**SUBMISSION TO DRAFT MAMRE ROAD STRUCTURE PLAN BY PETER GREEN THE
LANDOWNER OF LOT 26 DP255560, 199 ALDINGTON ROAD, KEMPS CREEK**

I own the property at 199 Aldington Road, Kemps Creek (Lot 26 DP255560), and write to you regarding the Draft Mamre Road Precinct Structure Plan for *State Environmental Planning Policy (Western Sydney Employment Area) 2009*.

Figure 1 Proposed Draft Mamre Road Precinct Structure Plan (NSW DPIE, 2019)

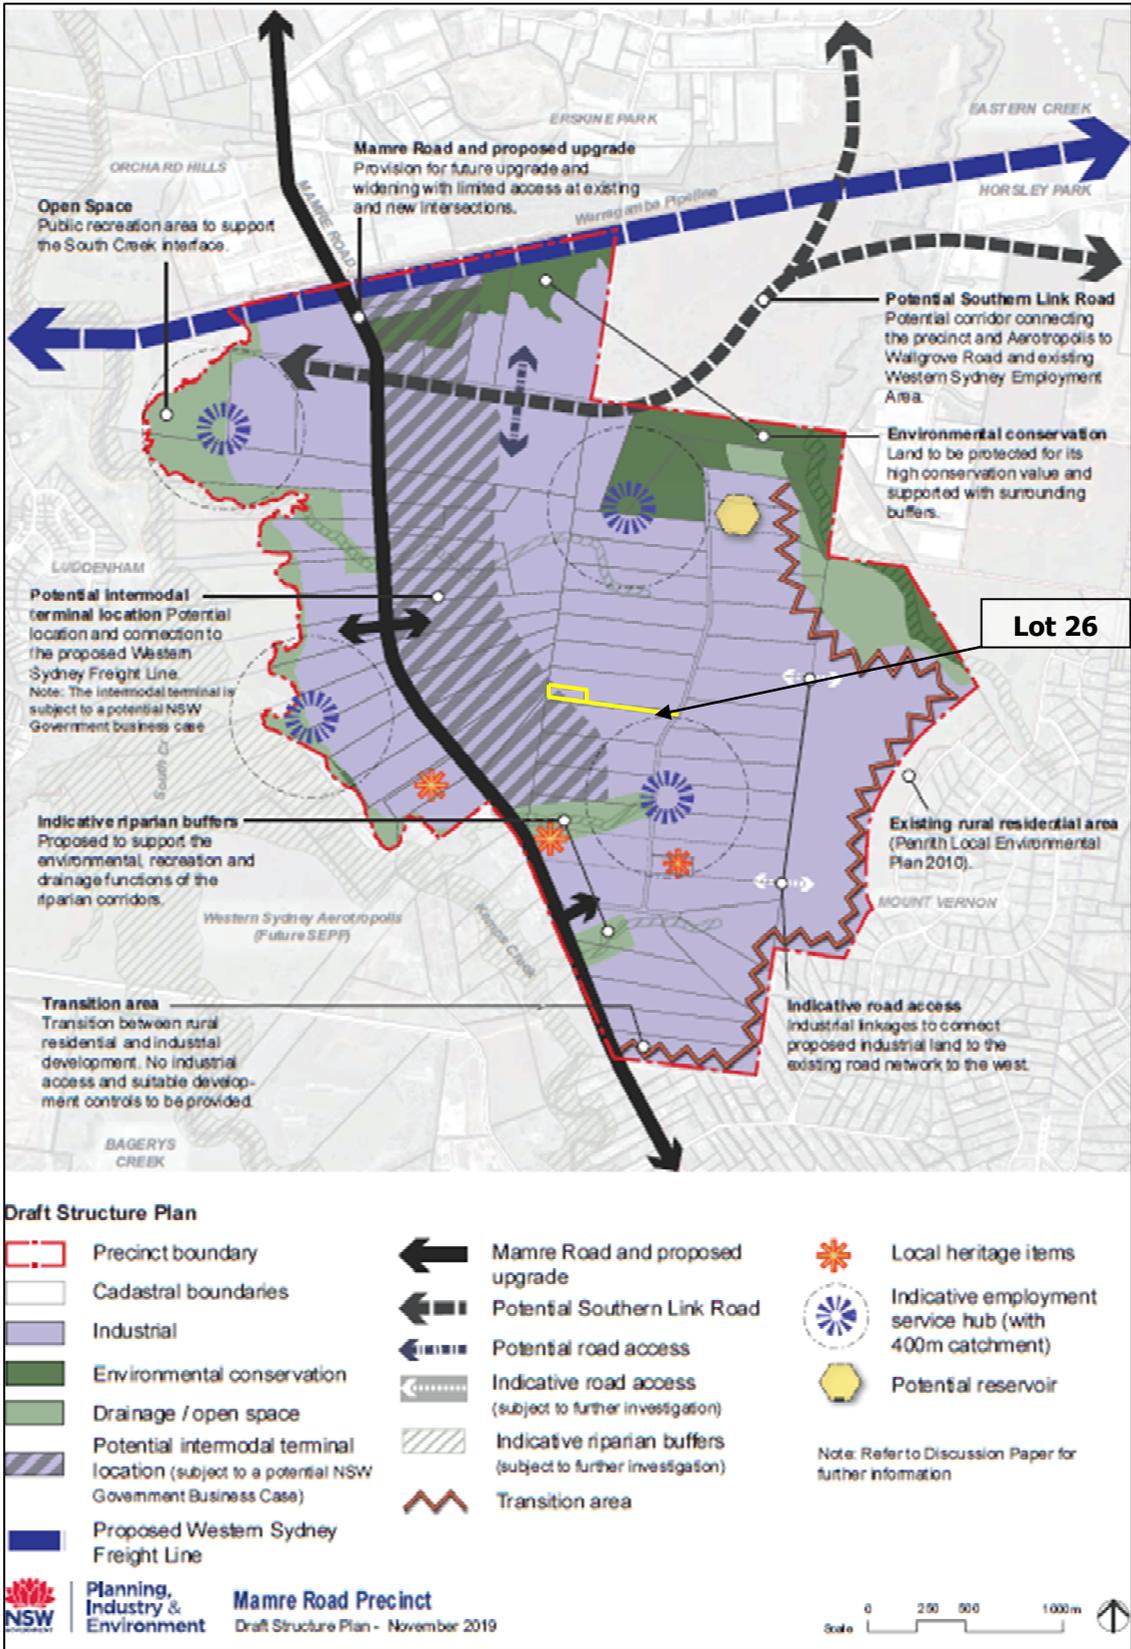
The Transport Infrastructure Investigation Area shown on **Figure 1** in **Section 1.0** above is too extensive. For landowners, it is not clear how they can use their lands once they are covered by this overlay. I am concerned about the requirement to obtain TfNSW concurrence for any development on such lands, and the Draft Structure Plan does not provide adequate details on this. It is also not clear to me when the Western Sydney Intermodal Terminal might be delivered, and who will be developing this piece of key infrastructure. It is therefore difficult for me to know whether part of my lot will be acquired in the future to support this Intermodal Terminal, or whether certain types of development will be prevented on my lot on the basis of possible conflict with the future Intermodal. It is also difficult to understand what I can develop on my site prior to the Intermodal Terminal being developed.

I consider this uncertainty to potentially sterilise the western-most portion of industrial zoned land on my lot in the meantime. This could prevent me from reasonably developing my site and contributing to optimum employment rates within the Precinct.

111
Figure 2 Draft Mamre Road Precinct Flood Affection (NSW DPIE, 2019)

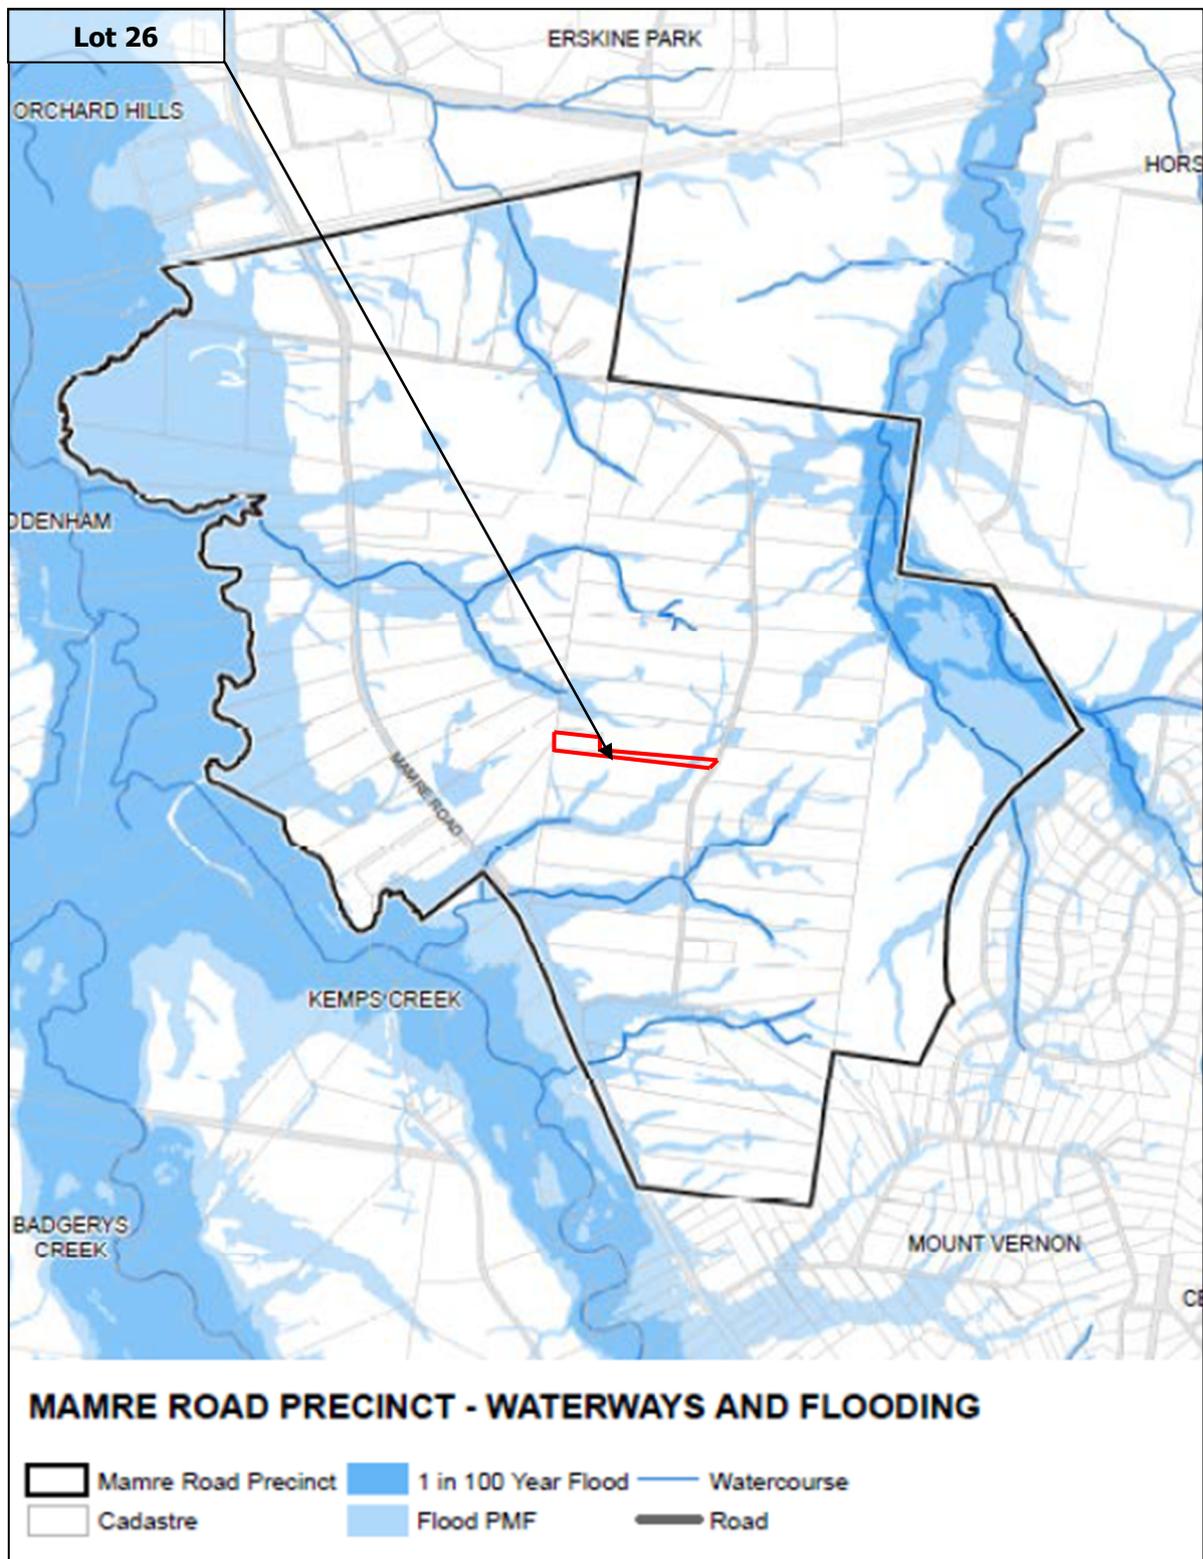
The Discussion Paper identifies how the Precinct's boundary has been aligned with the 1:100 flood zone. It is proposed to use the PMF as the buildable flood level for the Precinct. I consider this to be too strict and out-of-step with the approach taken by Penrith City Council and the Department for other nearby sites. I am also concerned that this could require me to undertake a higher level of assessment for development on my lot (affected by the PMF only – refer to **Figure 2** below), when this would not usually be required.
